Our Ref: 21BRT0549

Your Ref: DEV2022/1310

RE: 15 Nexus Way Southport, Traffic Response to Further Issues

TTM has been engaged to respond to further issues letter for a proposed health care use at the above address. This request from Economic Development Queensland is dated 9 September 2022 and refers to Application Number DEV2022/1310.

PROJECT HILL STREET, SOUTHPORT
DRAWING TITLE VEHICLE ACCESS ARRANGMENTS
SWEPT PATH ANALYSIS

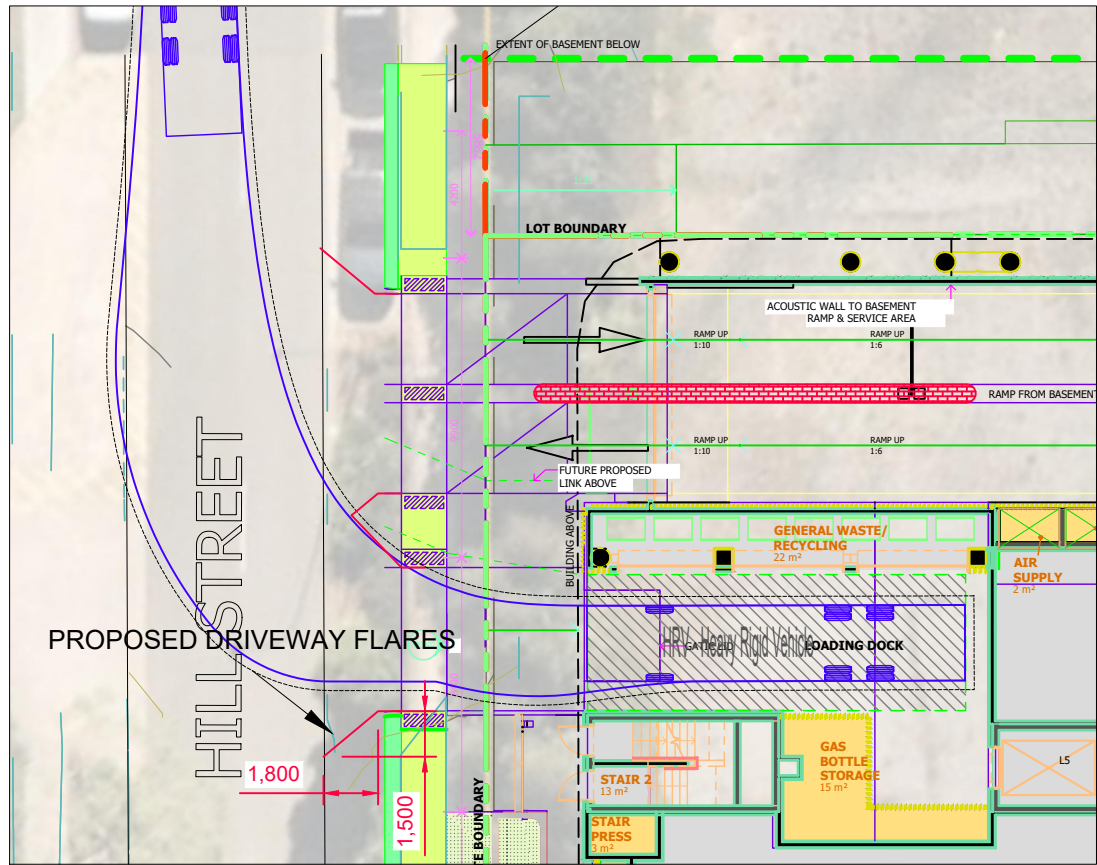
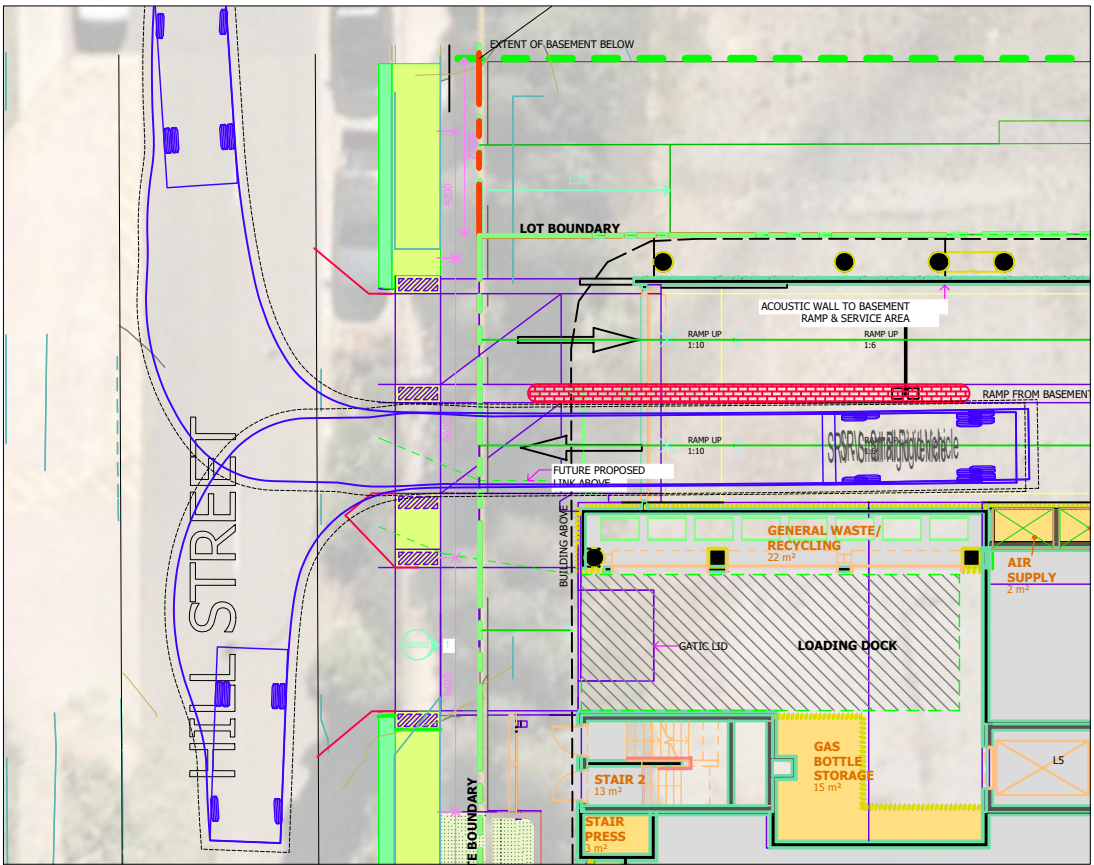
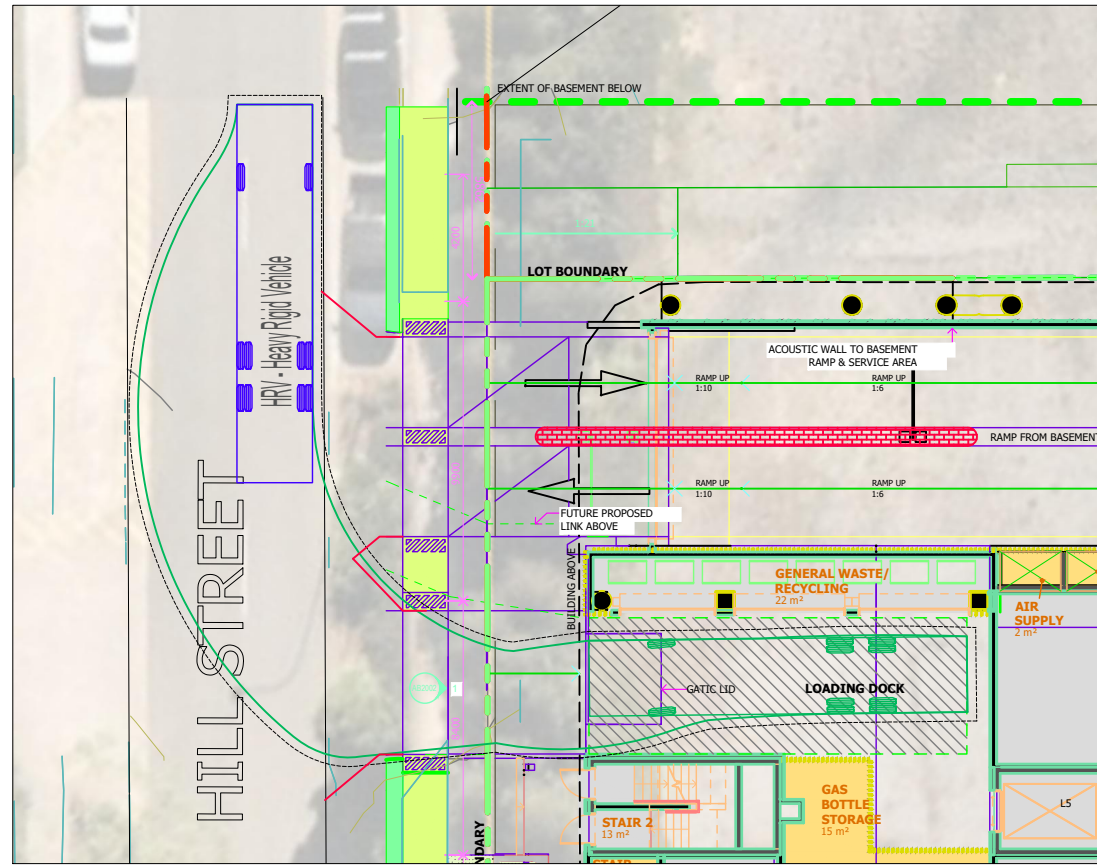
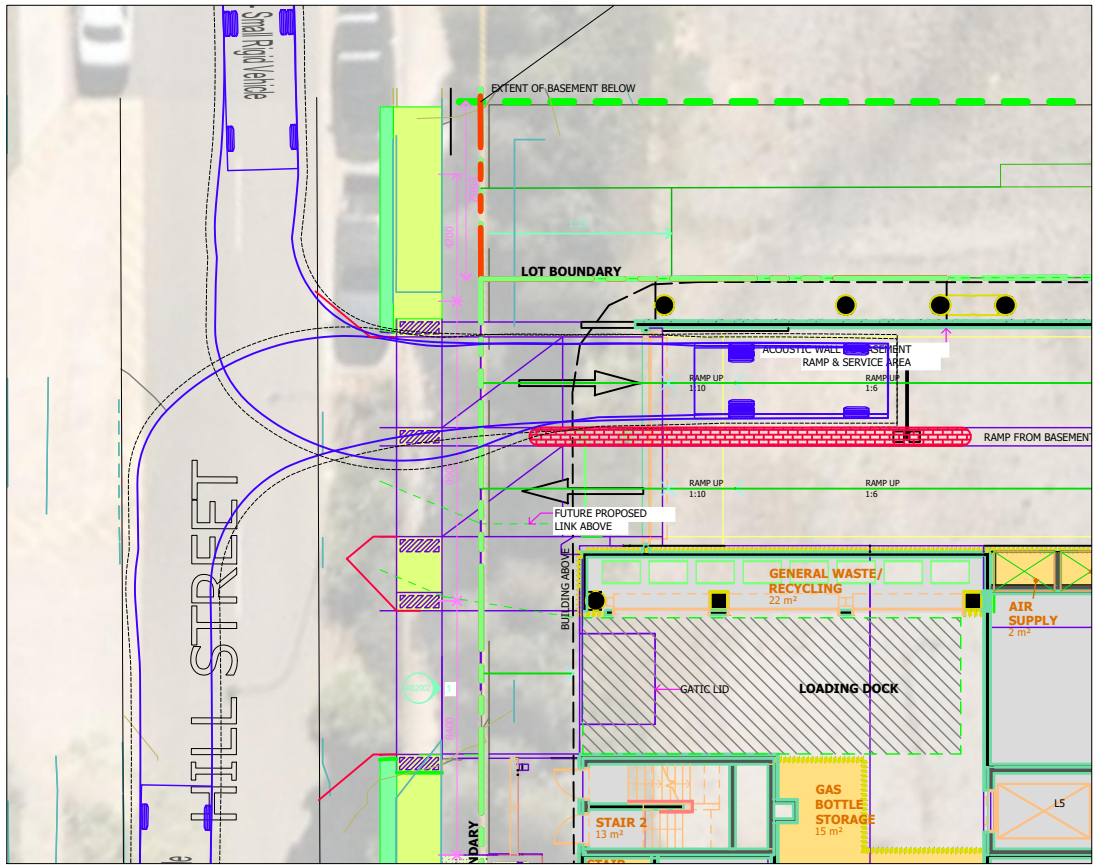
Item 3(f) of the EDQ letter requires demonstration that the ground floor service vehicle bay is adequate considering that a hospital/ research facility use requires AV access.

Item 3(g) of the EDQ letter requests swept paths of the largest vehicle accessing this loading bay.

The largest design vehicle that can access the proposed loading bay is a 12.5m HRV. This is a suitable vehicle to provide for Energex access and large scale deliveries. Advice from Northwest Health confirms that their facilities are not serviced by AV's as a usual practice and deliveries can be managed to avoid this.

Consistent with the response to item 3(f) the swept path for a HRV is shown in **Appendix B**.

PROJECT	HILL STREET, SOUTHPORT	PROJECT NUMBER	21BRT0594	ORIGINAL SIZE	A3
DRAWING TITLE	VEHICLE ACCESS ARRANGMENTS SWEPT PATH ANALYSIS	DRAWING NUMBER	21BRT0594-15	REVISION	A
		DATE	20 Sep 2022	SHEET	1 OF 1

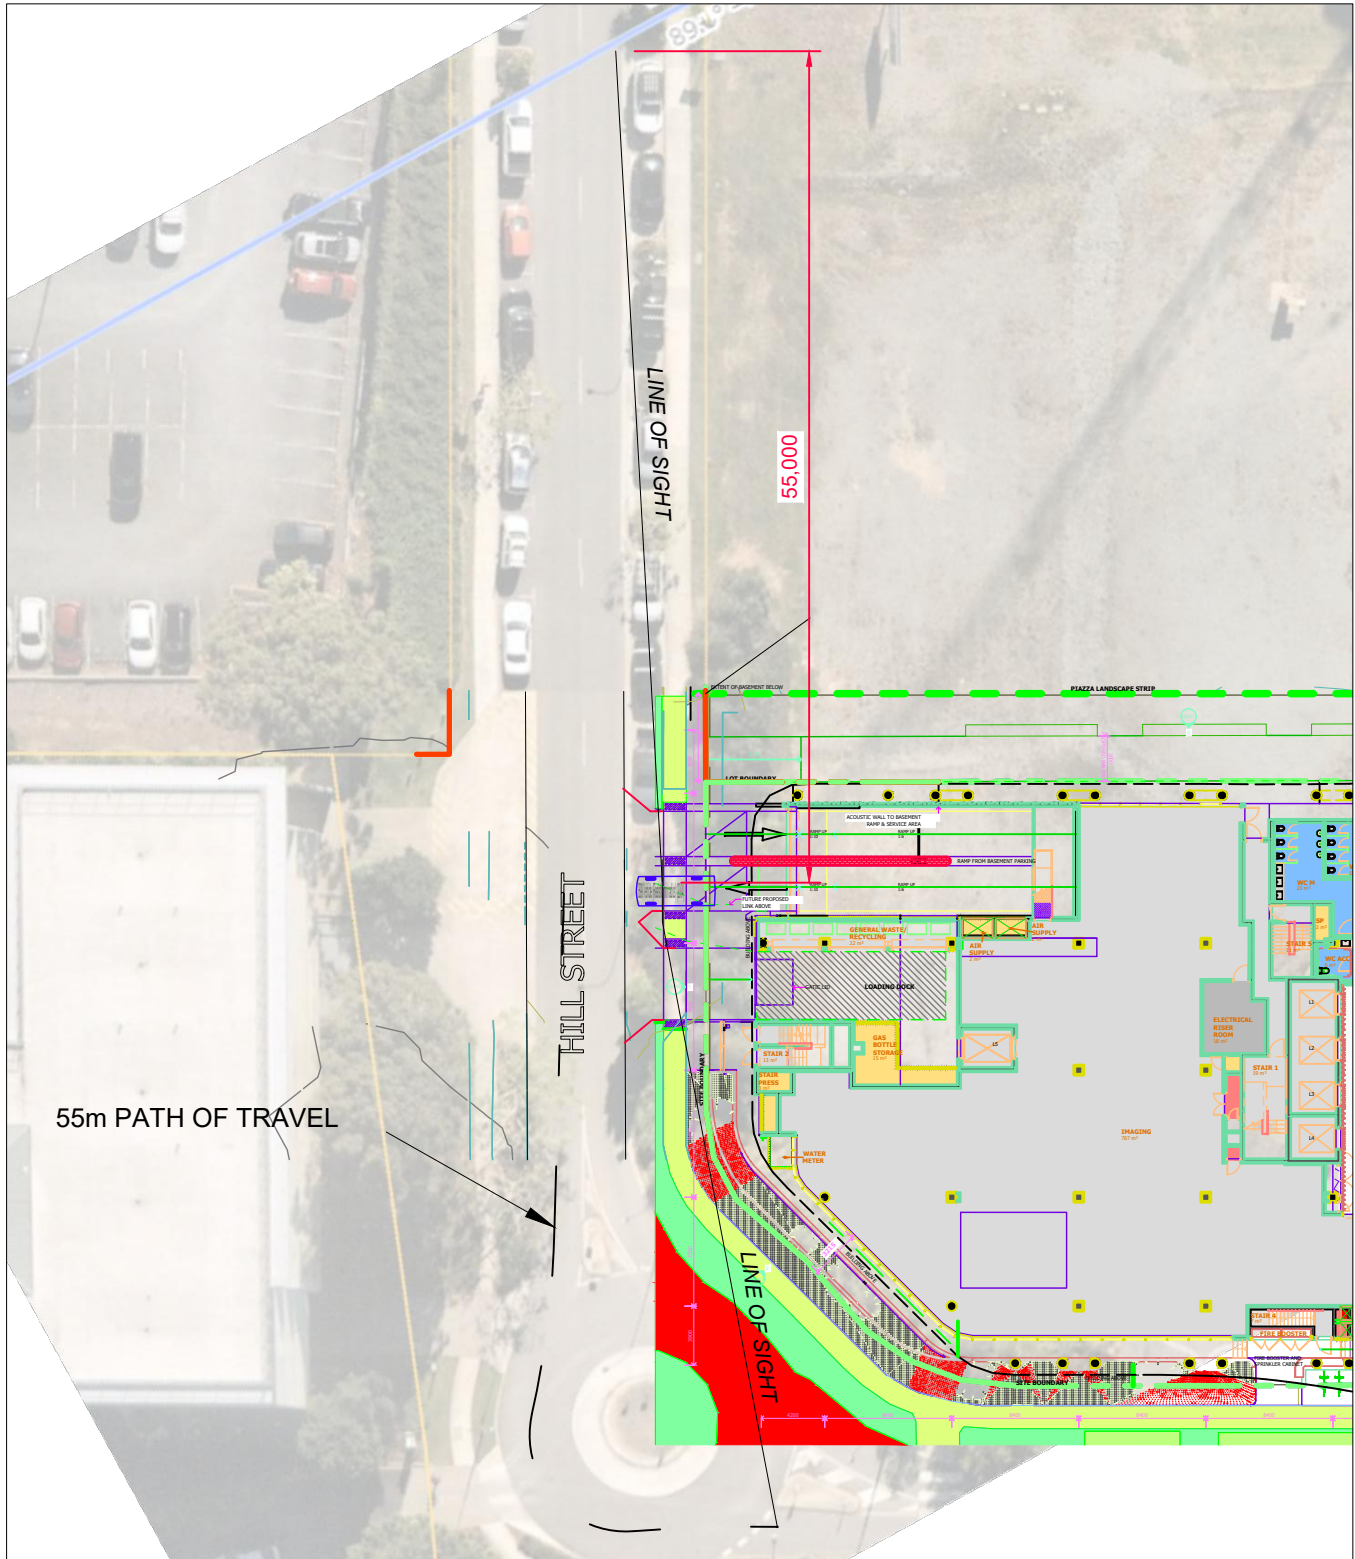
Item 3(t) of the EDQ letter requests that sight distance o 35m minimum, 55m desirable is demonstrated.

A sight distance diagram is provided in **Appendix C** demonstrating the available sight distance. It is noted that significantly less sight distance is required to the south, given the operating speed of vehicles through the roundabout is expected to be 25km/hr, rather than the Hill Street general design speed of 40km/hr.
